Attachment I to TXX-18066
Evaluation of Proposed Change

1.0 SUMMARY DESCRIPTION

Pursuant to 10 CFR 50.90, "Amendment of License or Construction Permit at Request of Holder," Vistra Operations Company LLC (Vistra OpCo) requests Nuclear Regulatory Commission (NRC) review and approval of a revision to the Comanche Peak Nuclear Power Plant (CPNPP) Emergency Plan for Units 1 and 2. This request proposes changes to the Emergency Plan to extend staff augmentation times and reduce the number of required Emergency Response Organization (ERO) positions.

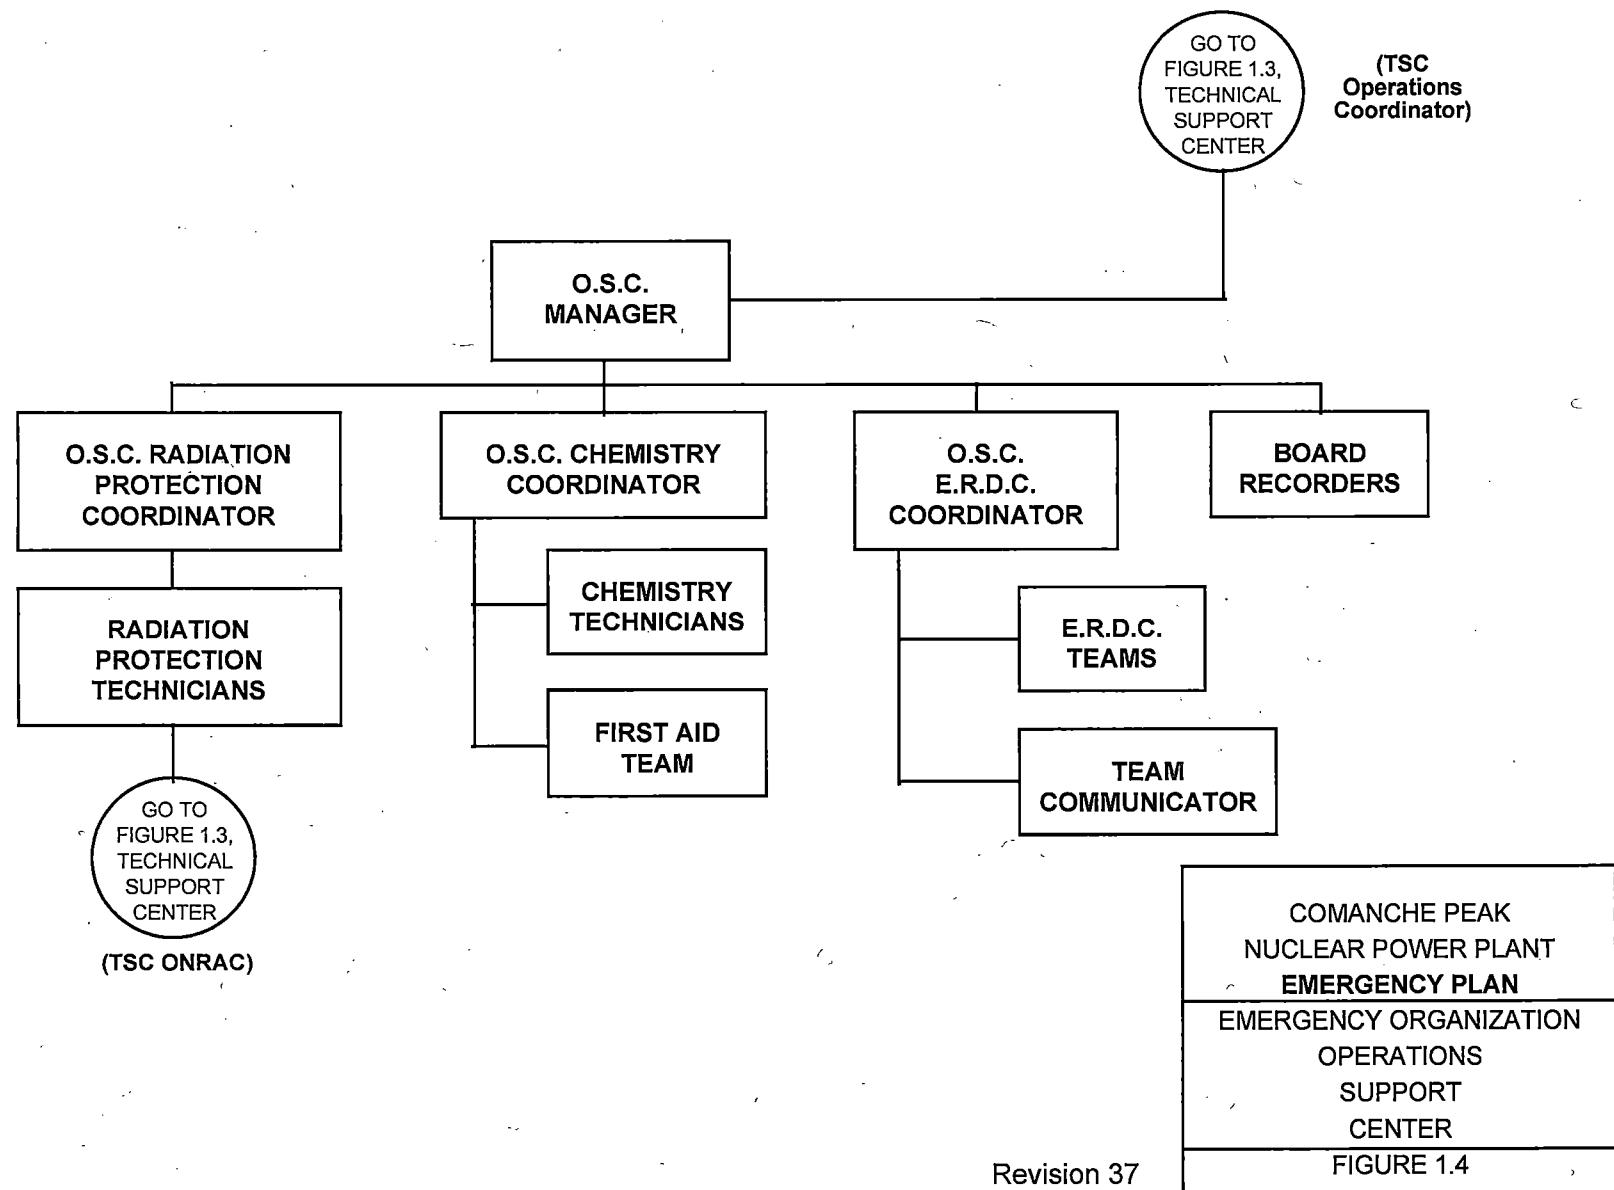
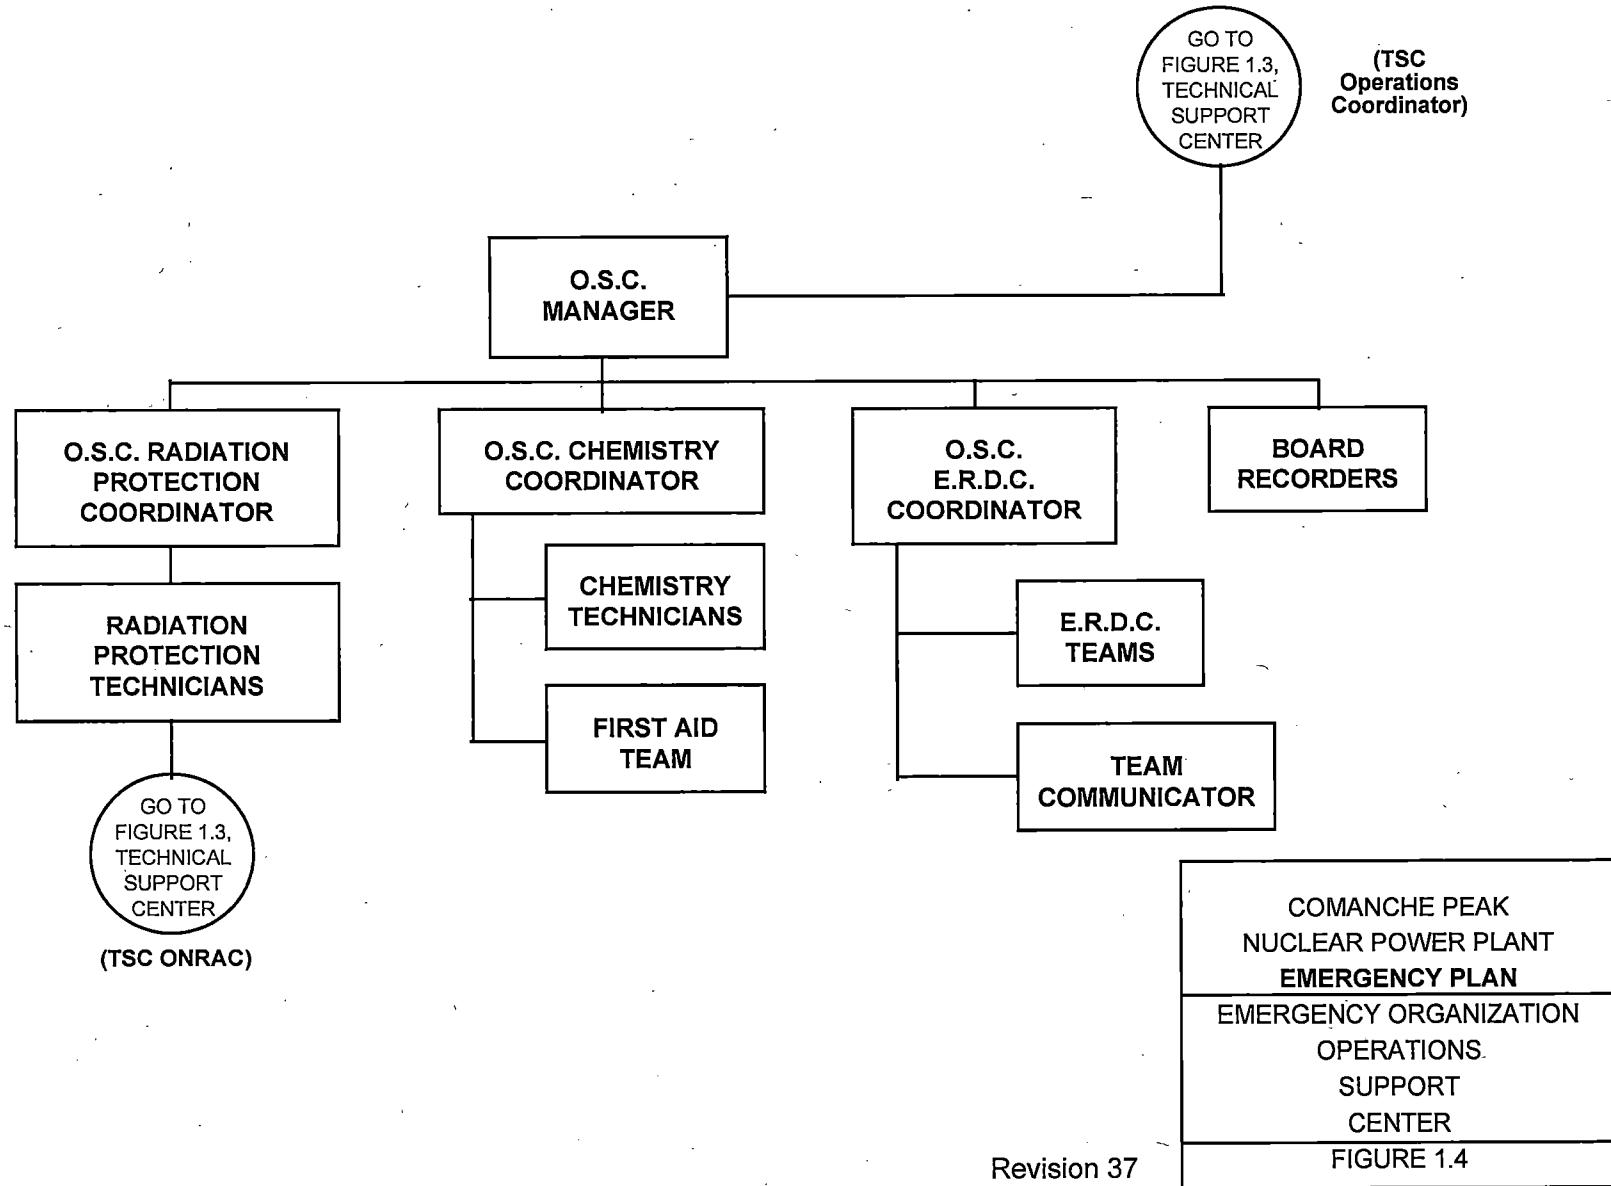
Emergency Plan Section	Before (Rev. 42)	After (Pending Revision Number)	Reason for Change
Table 1.2	Staff and activate the Emergency Response Facilities: Technical Support Center (TSC) Operations Support Center (OSC) Emergency Operations Facility (EOF)	Staff and activate the Emergency Response Facilities: Technical Support Center (TSC) Operations Support Center (OSC) Emergency Operations Facility (EOF) Joint Information Center (JIC)	Added Joint Information Center.
Table 1.2 Note 1	EOF activated at the SAE.	EOF and JIC activated at the SAE.	Added Joint Information Center.
Figure 1.2	*Maintenance Personnel	deleted	Remove reference to on shift Maintenance personnel.
Figure 1.2	Control Room Communicators	Control Room Communicator	Reflect one dedicated Control Room Communicator.
Figure 1.2	Plant Equipment Operators	Nuclear Equipment Operators	Title change to reflect current practice.
Figure 1.3	Communicators	Communicator	Reflect one Communicator in TSC.

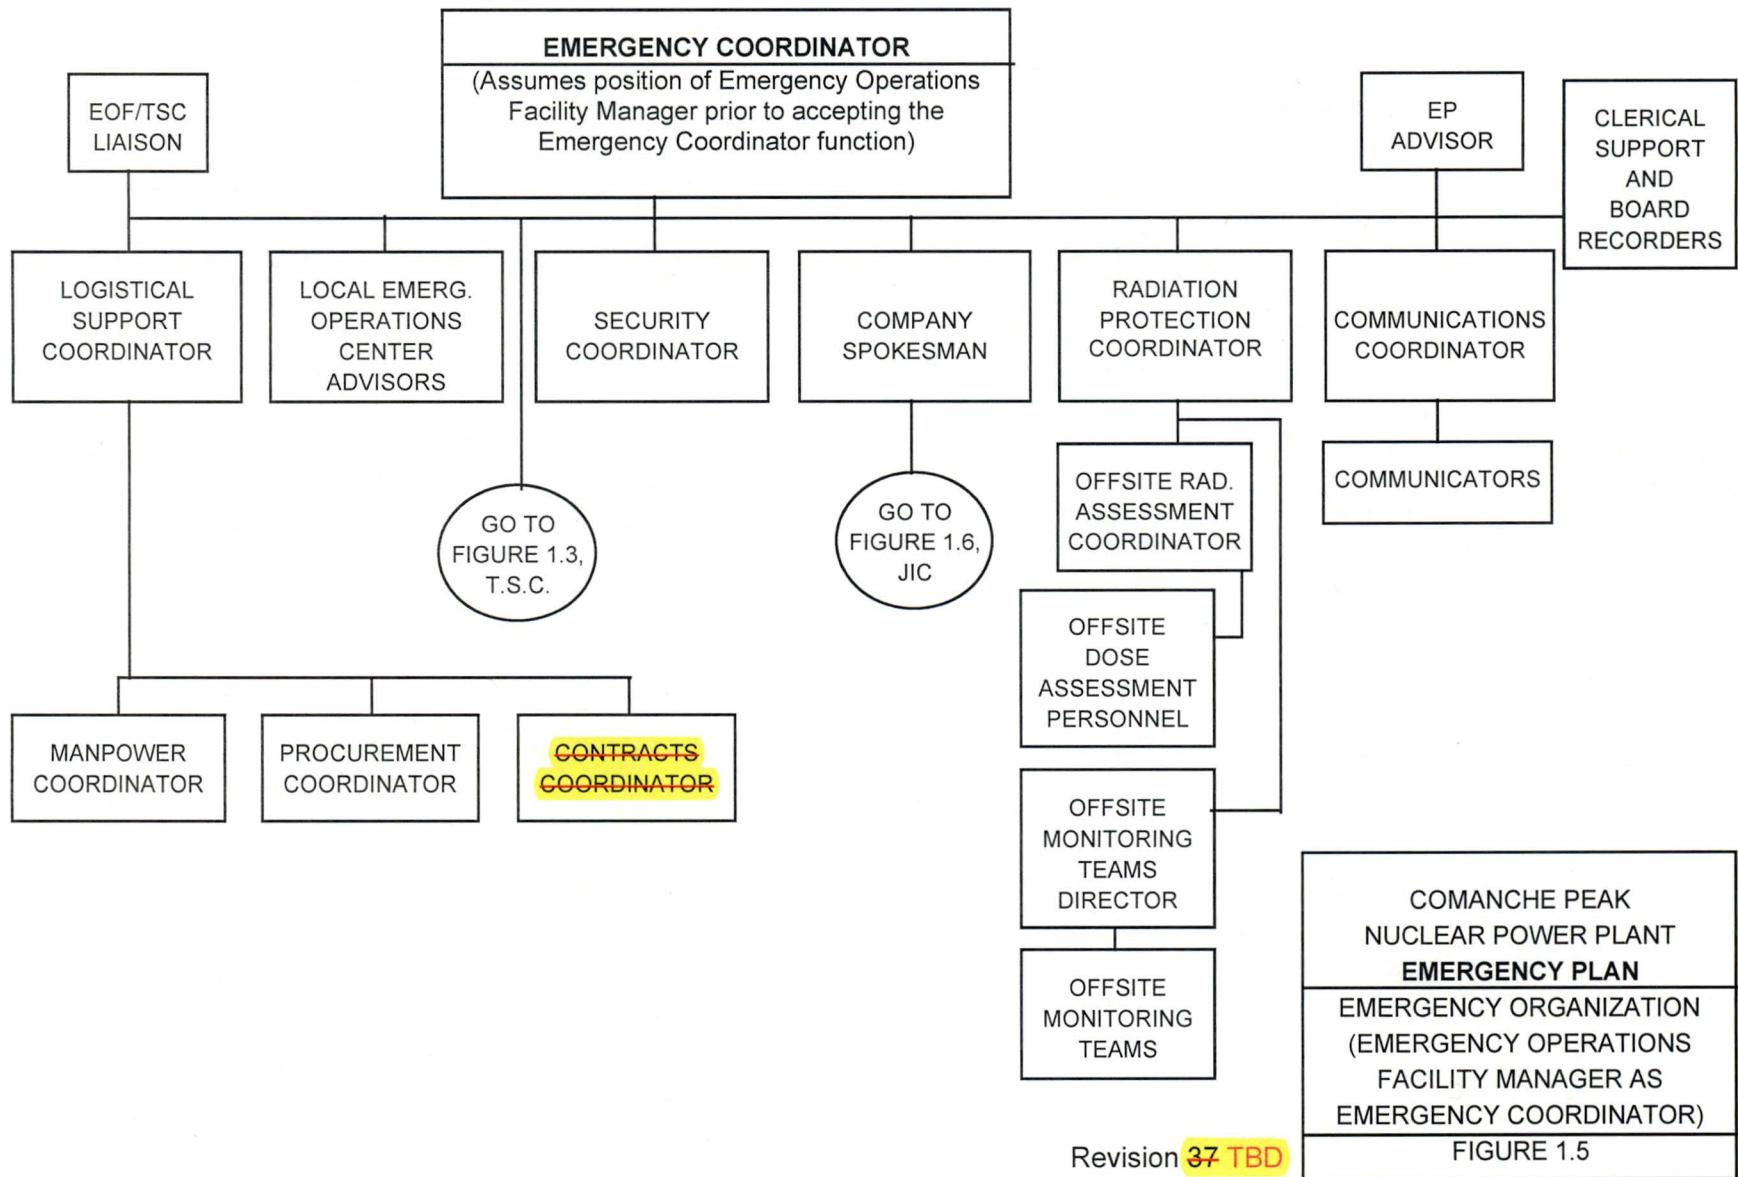
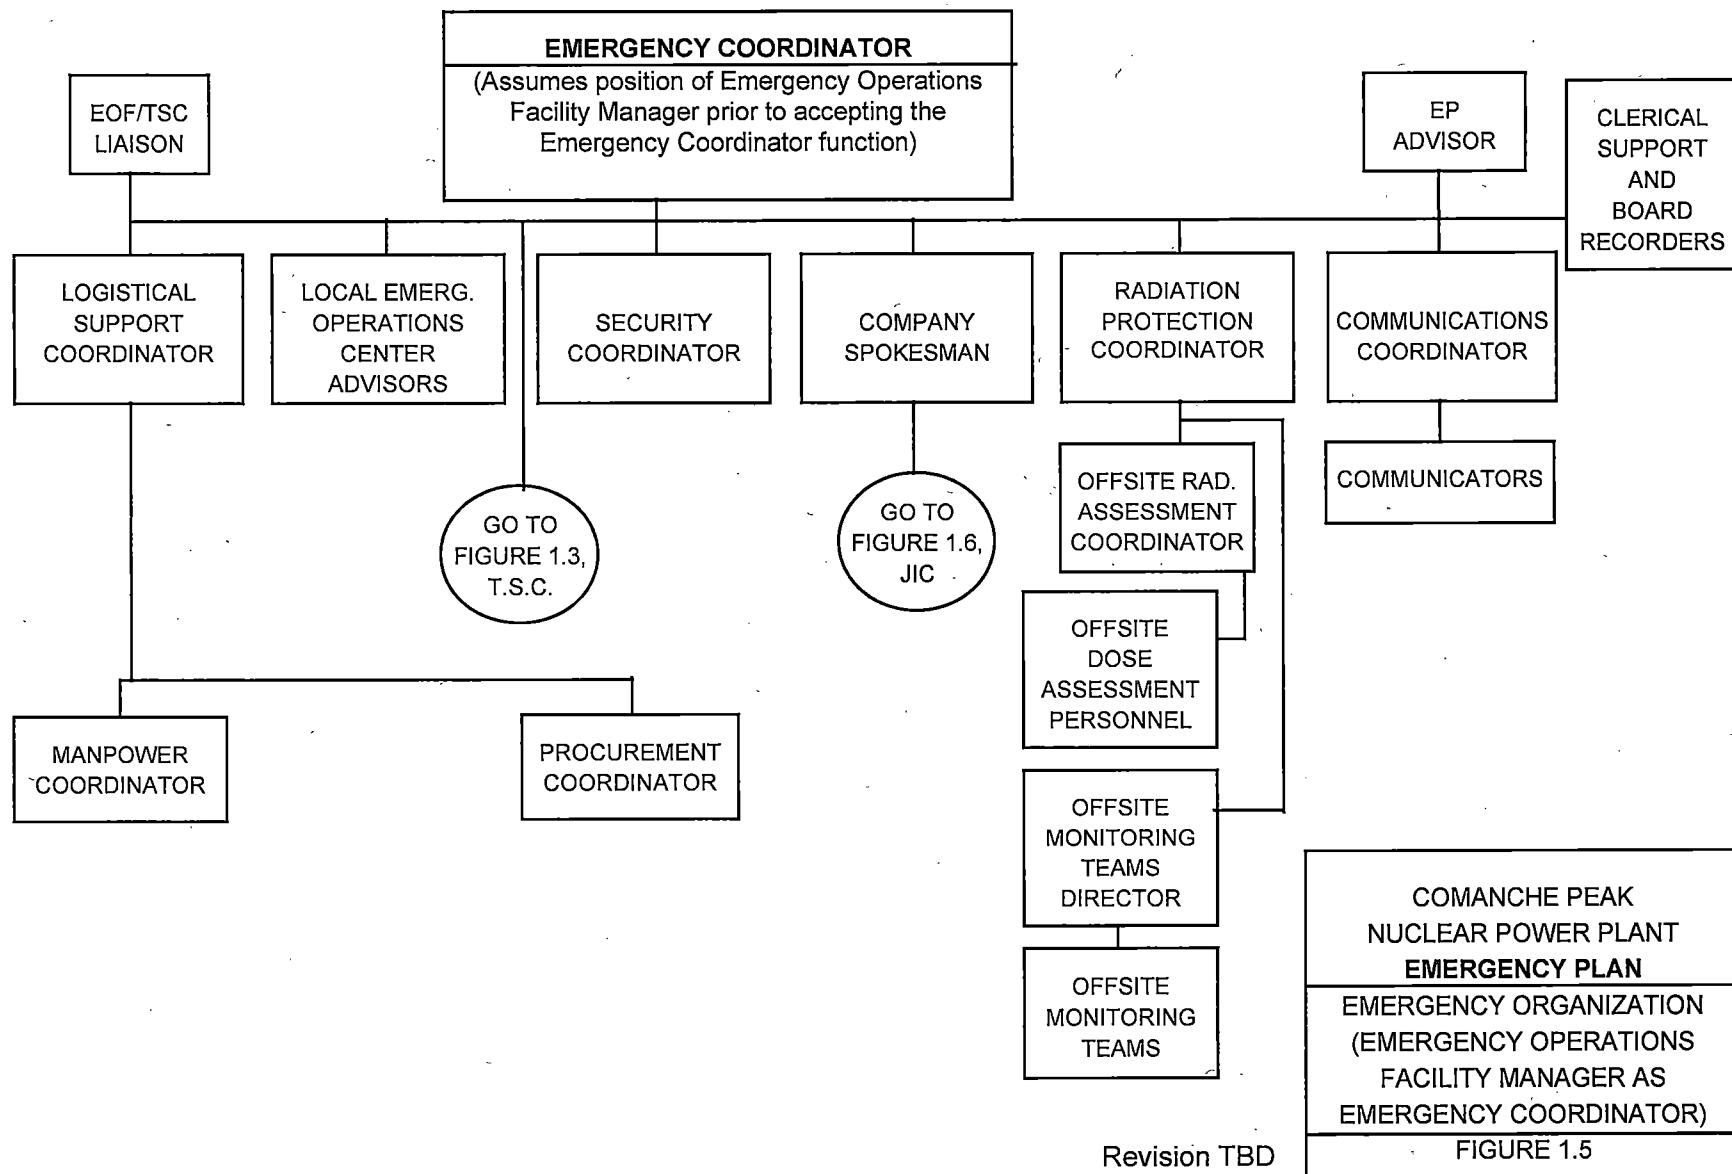
Figure 1.5	Contracts Coordinator	deleted	Reflect elimination of the position. The Procurement Coordinator will perform contract functions.
